**TOWN OF BLIND RIVER
REQUEST FOR TENDER
NEW BLIND RIVER WATER TREATMENT PLANT INTAKE AND LOW LIFT PUMPING STATION
CONTRACT NO. PS-2026-01**

**ADDENDUM #8
March 4th, 2026**

DRAWING TITLE:
REMOVALS PLAN

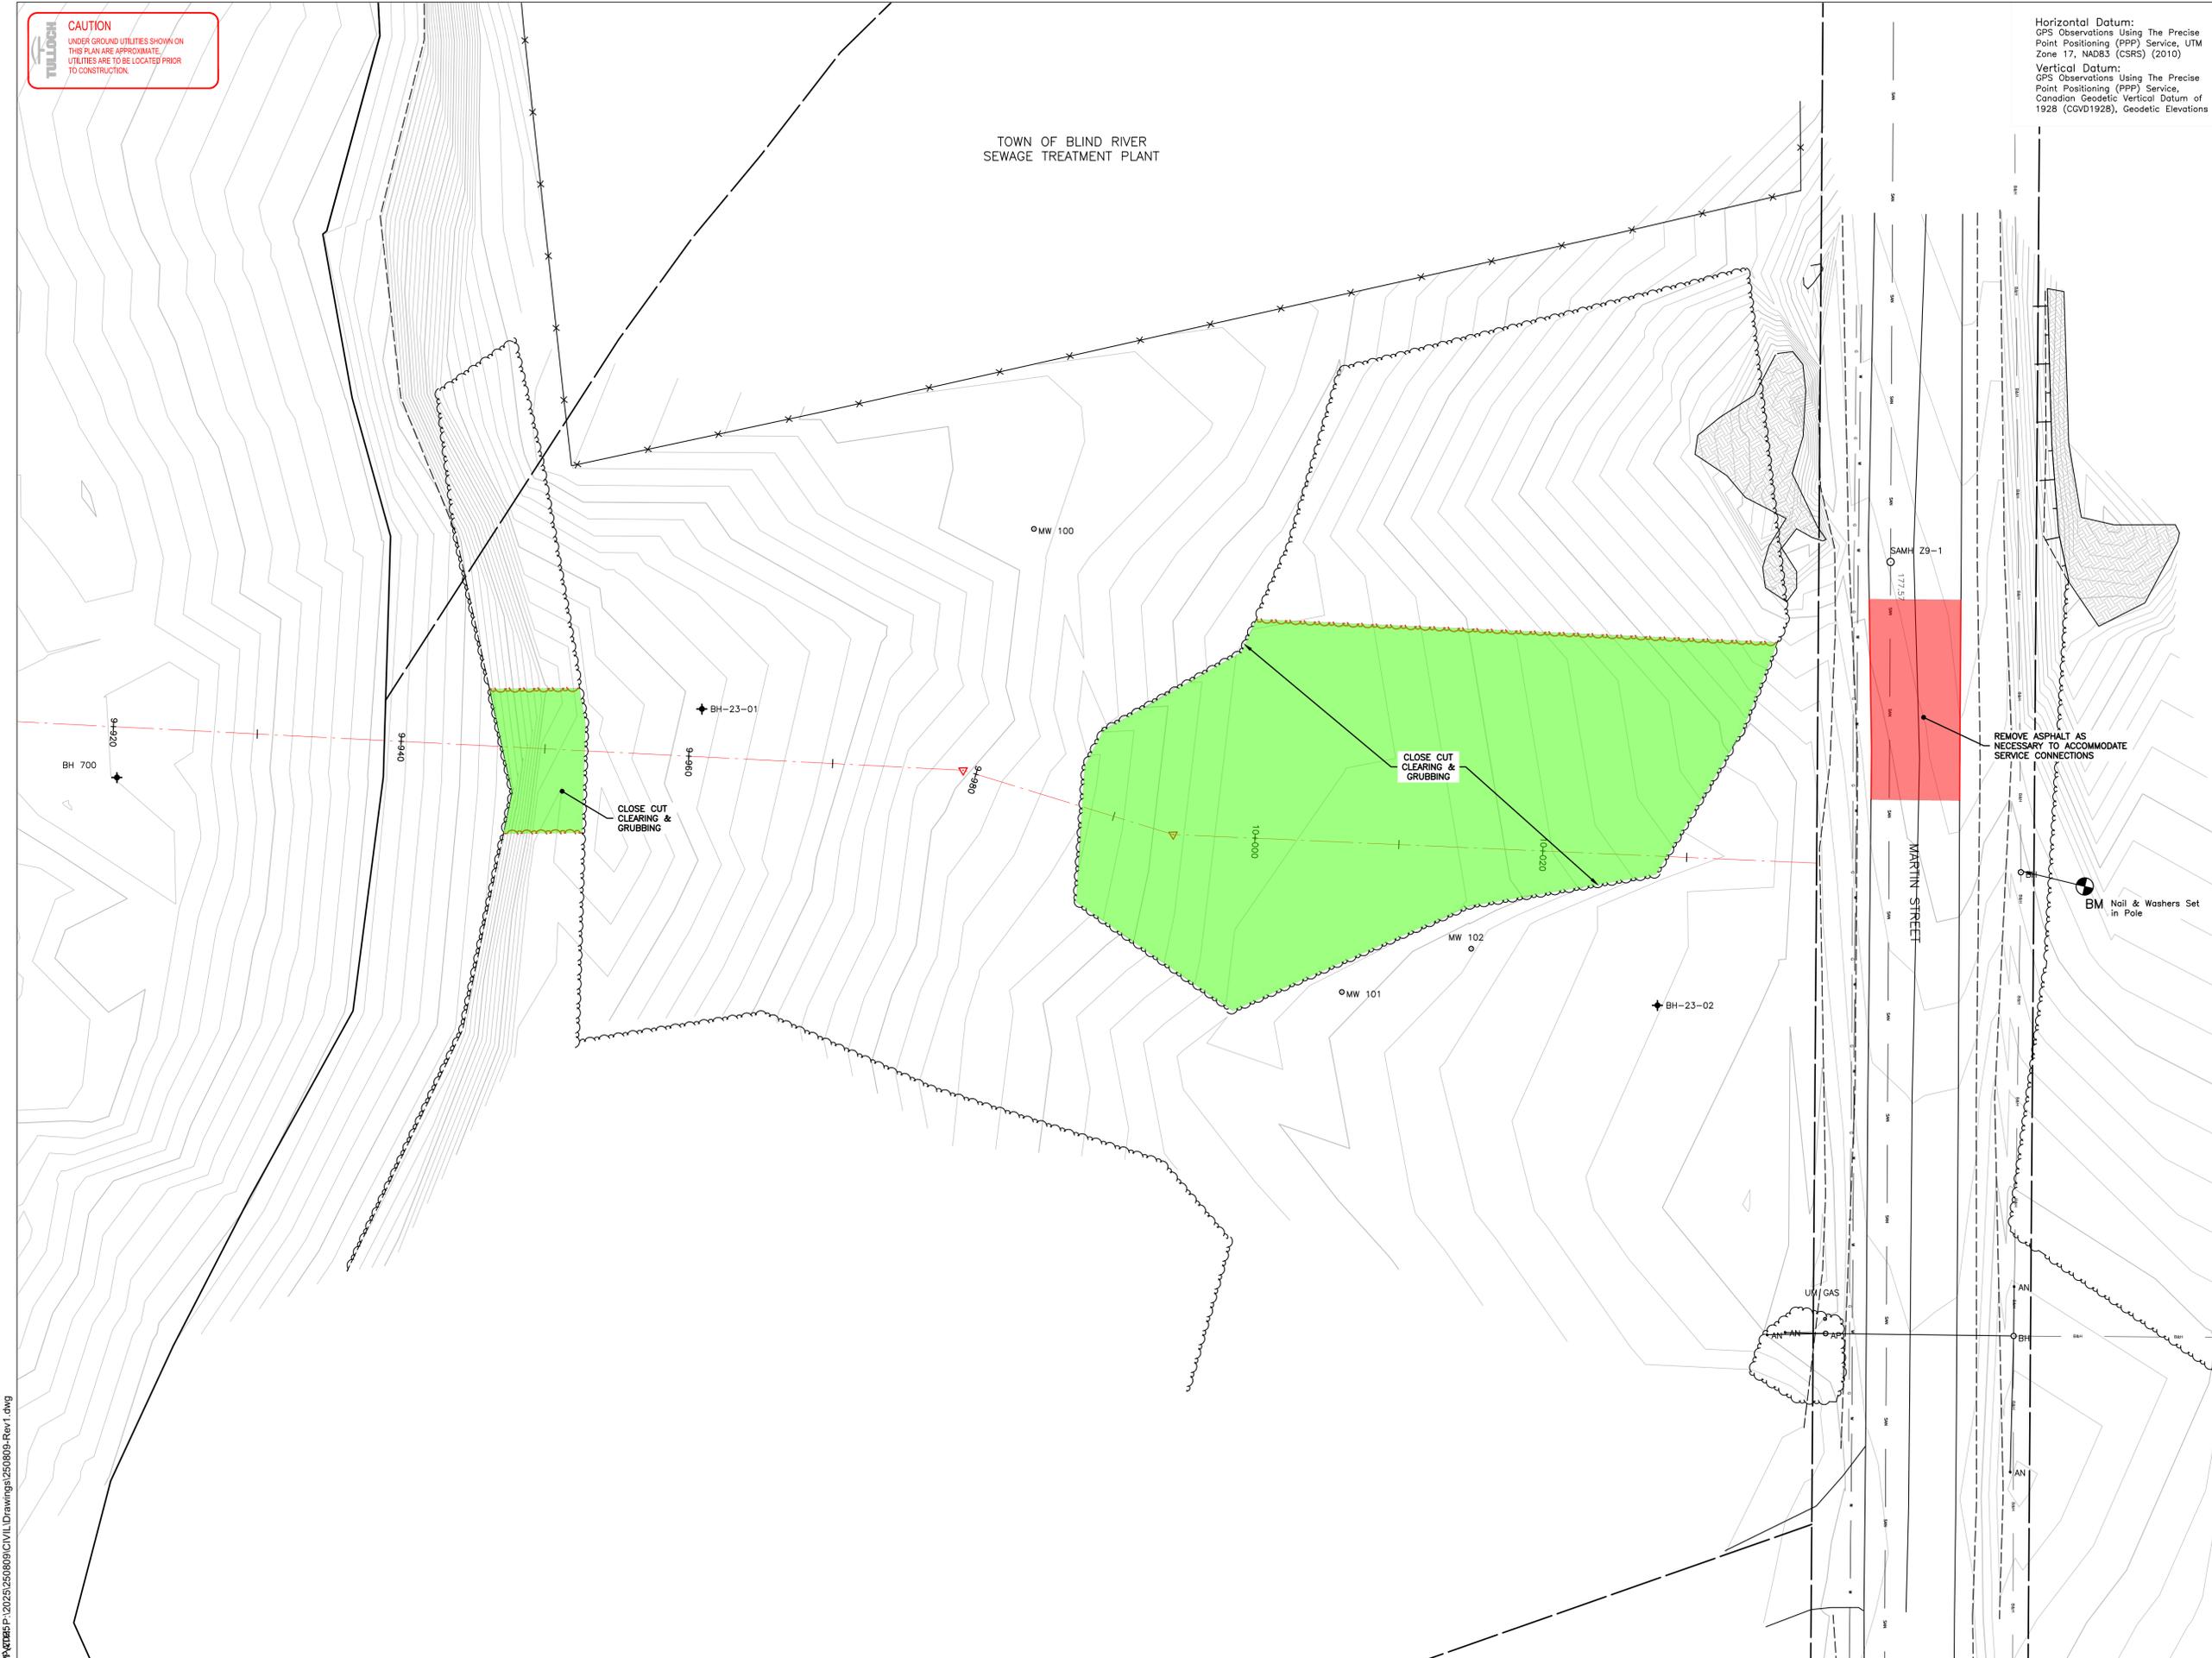
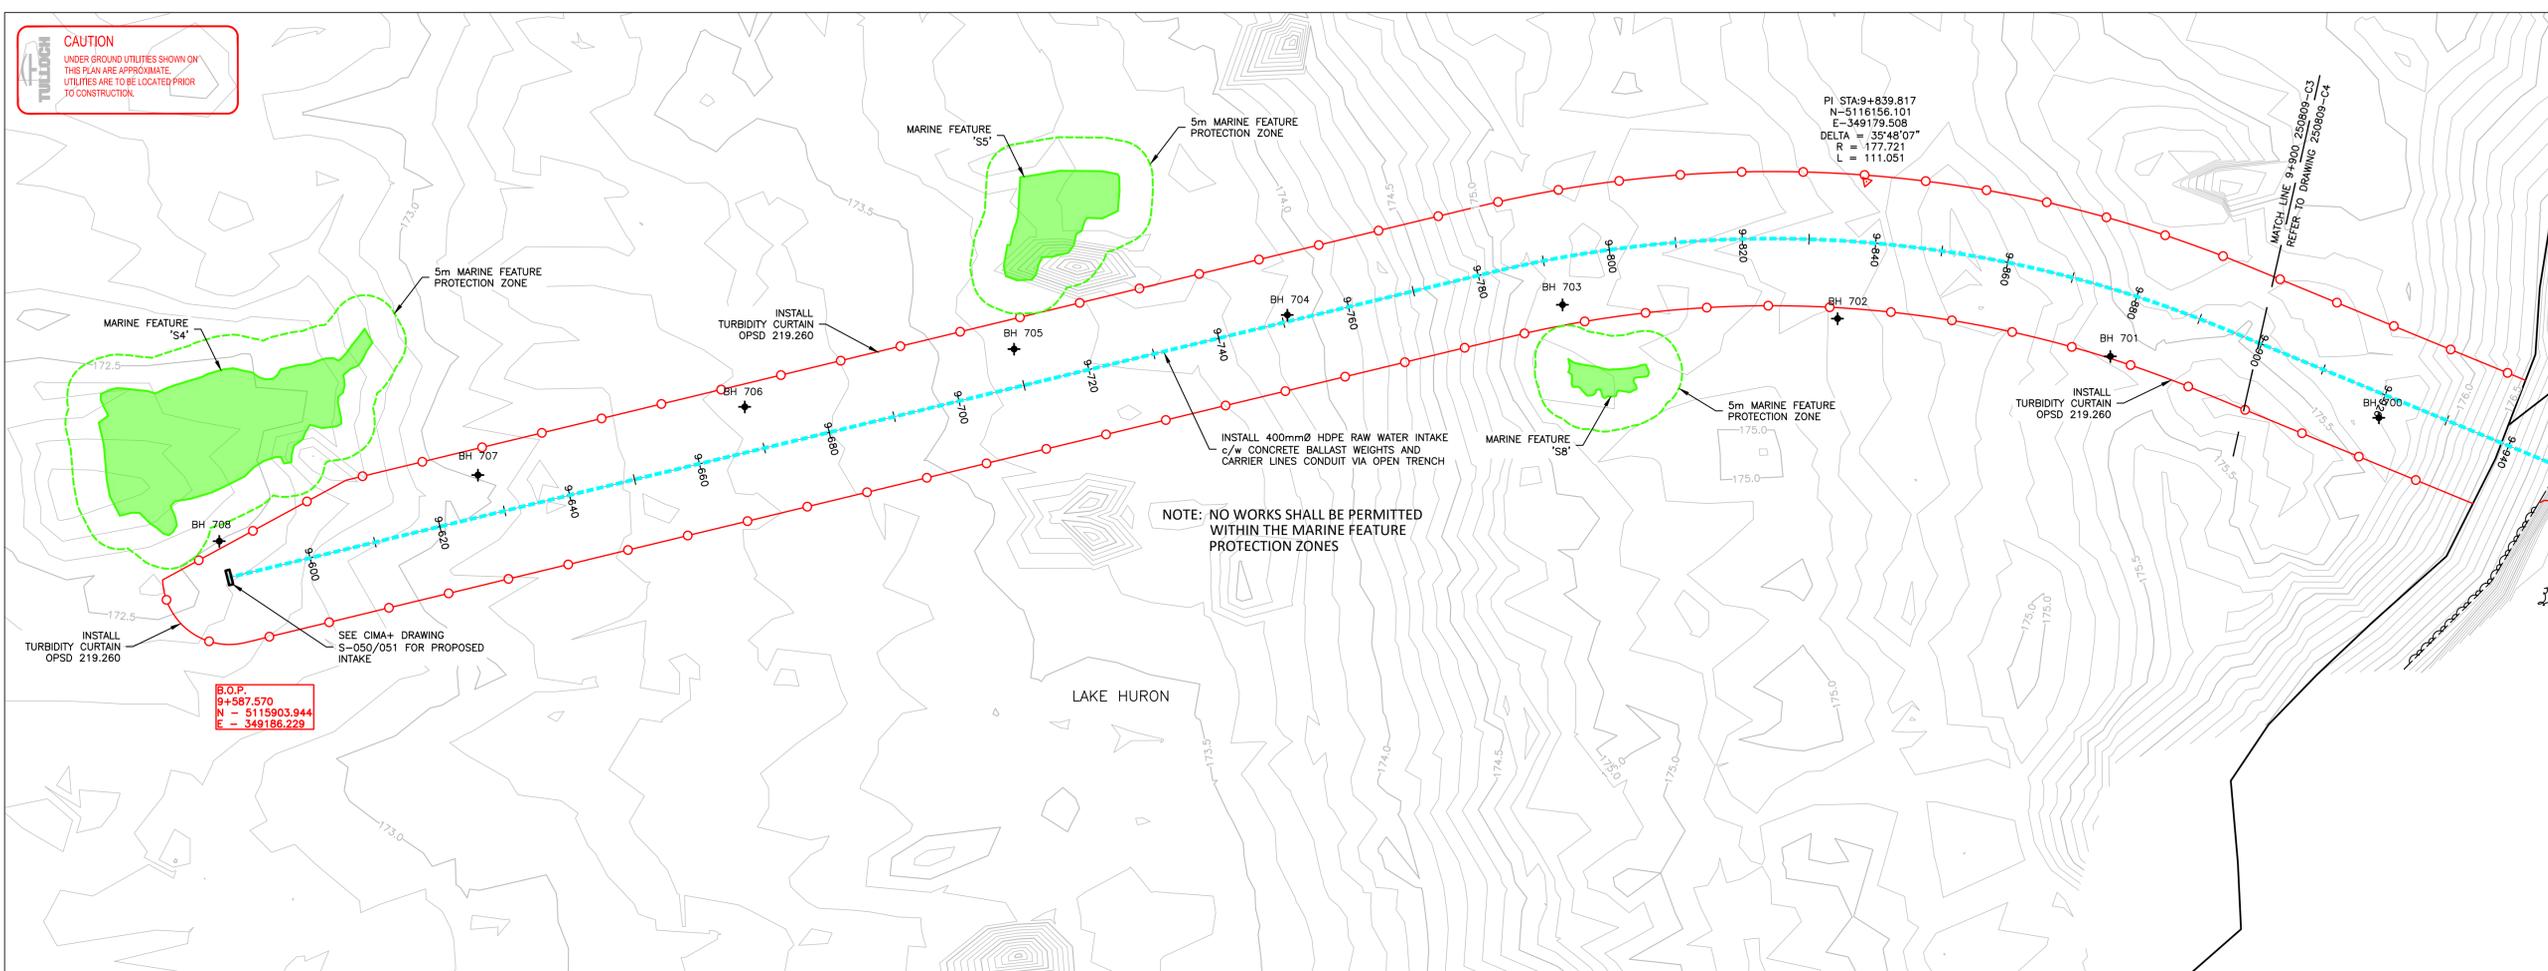
Please note, the intake and carrier lines installation has been changed from Horizontal Directional Drilling (HDD) to Conventional Open Trenching. All references to HDD shall be removed from the tender and replaced with Open Trenching, per OPSS.MUNI 441. The intake and carrier lines shall be installed on concrete ballast blocks to the lines and grades indicated and the lakebed backfilled. Attached are updated design drawings C1 thru C6.
